R.F. Section

Number	PC 586	Revision	2
--------	--------	----------	---

NRK TX 2020

586 1 Top Layer

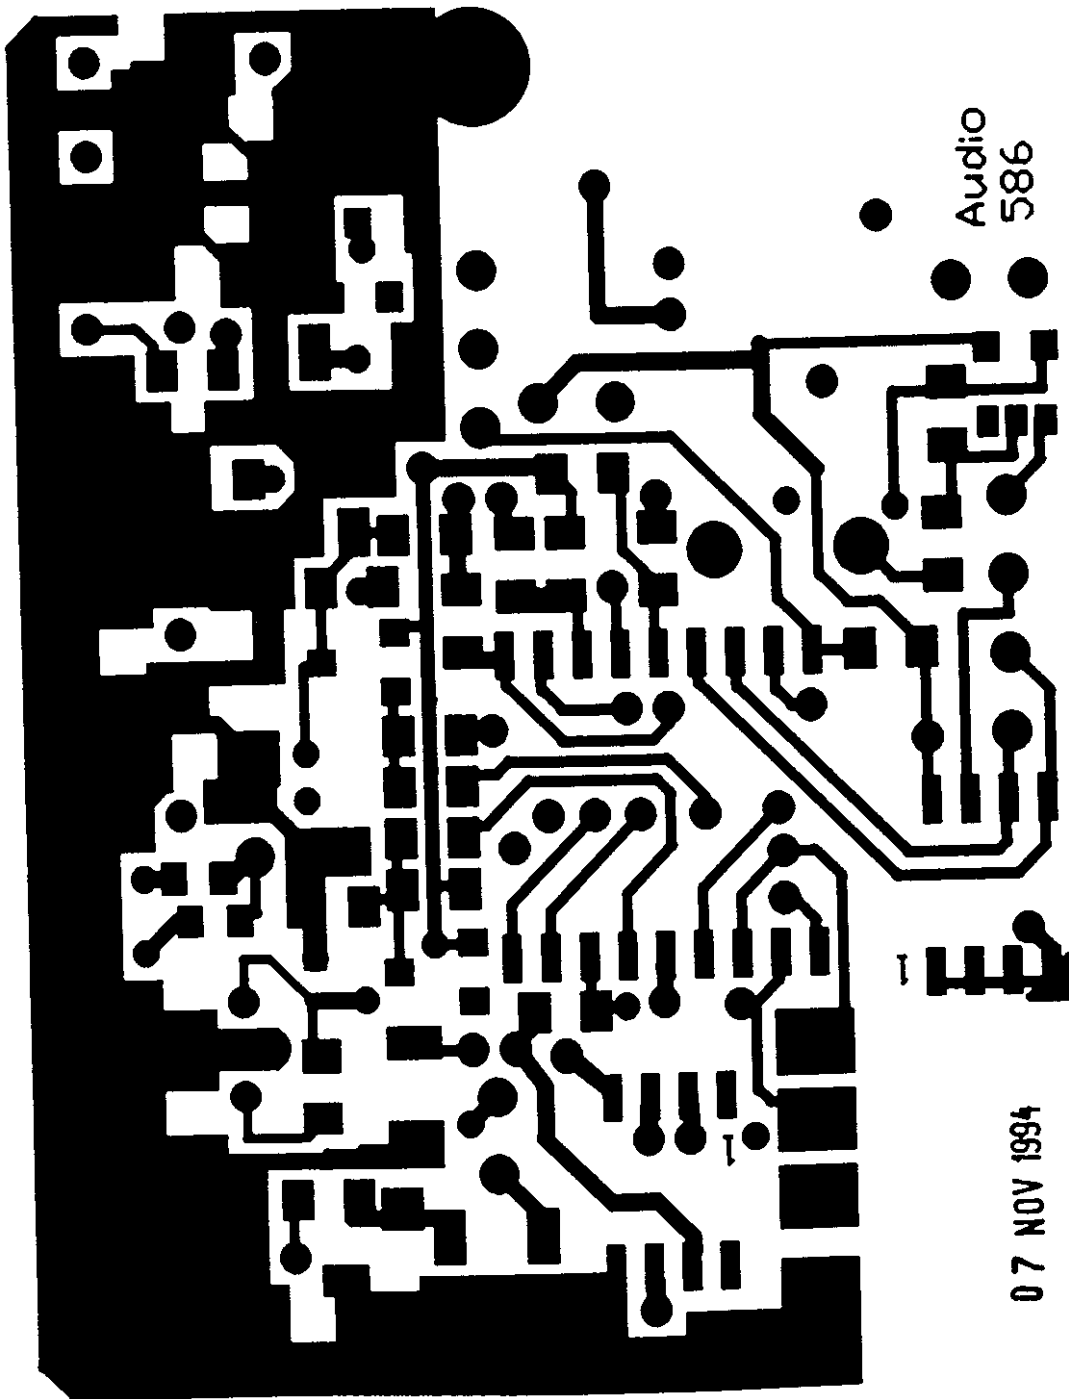
- ① R29 10K → 4K7
- ② DEVIATION SET FROM 45KHz → 35KHz
- ③ 100pF on IC1 pins ③④

Audio amp & Compander			
Size	Number	Revision	1
A3	PC 585		
Page: 686/1	Sheet: 1 of 1	Drawn by: JPR

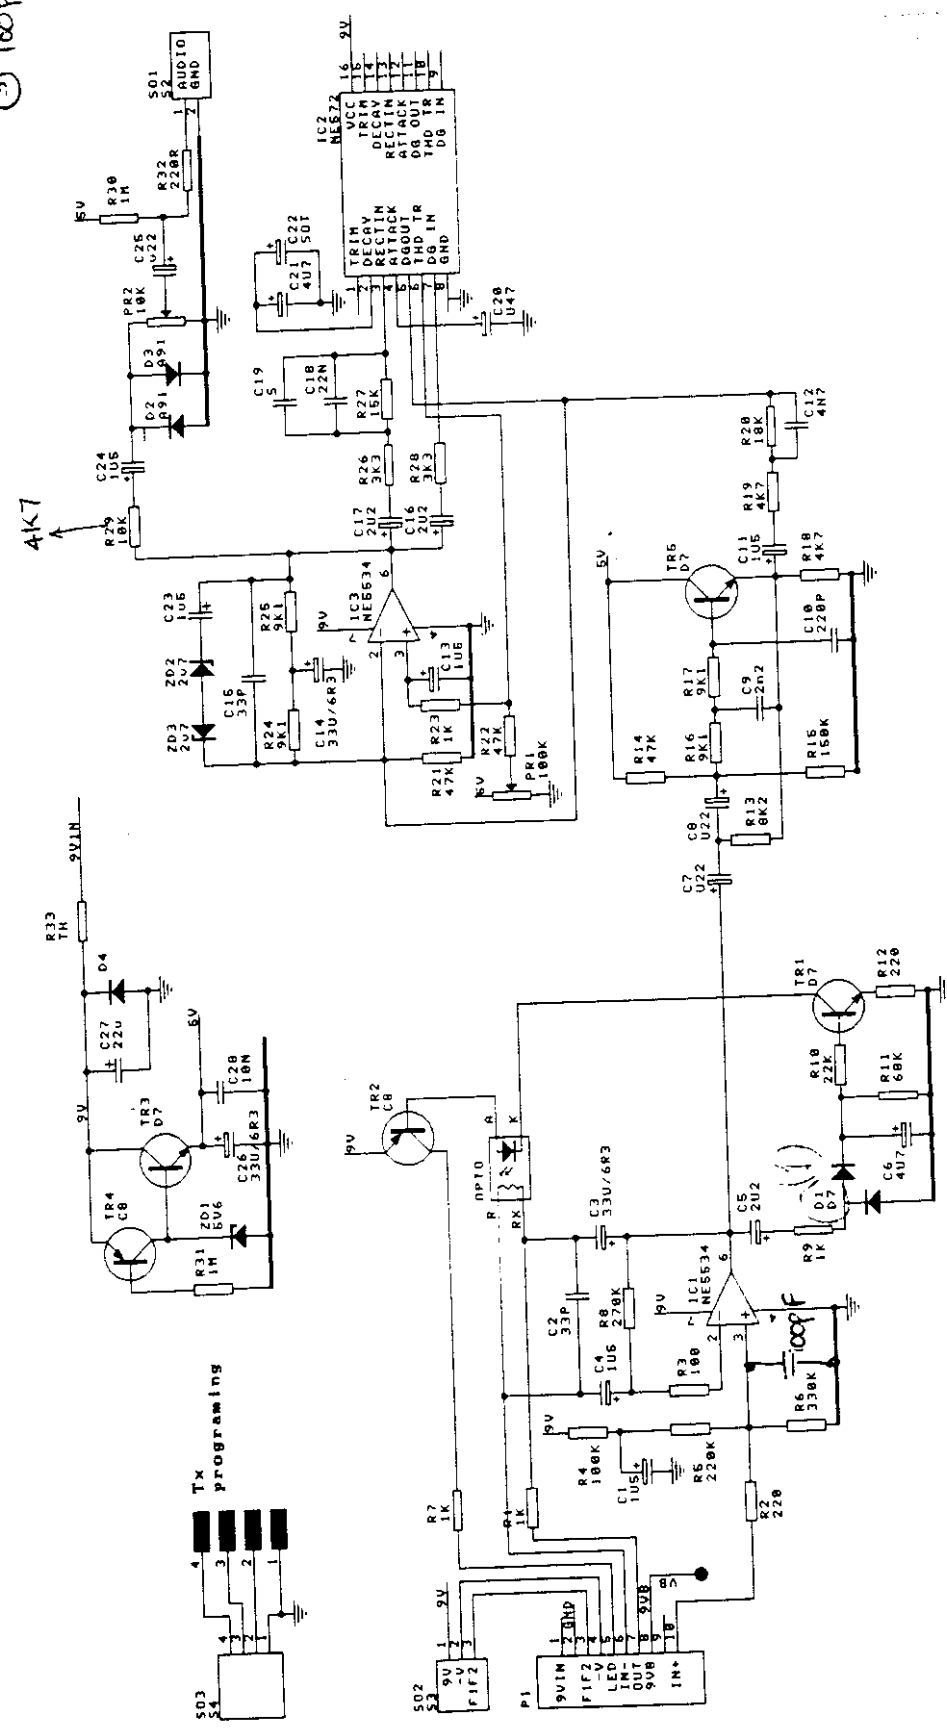
- (1) Chngs R1 from 10K to 4K7
- (2) 2D3? NF
- (3) 2D2? NF
- (4) C23? NF
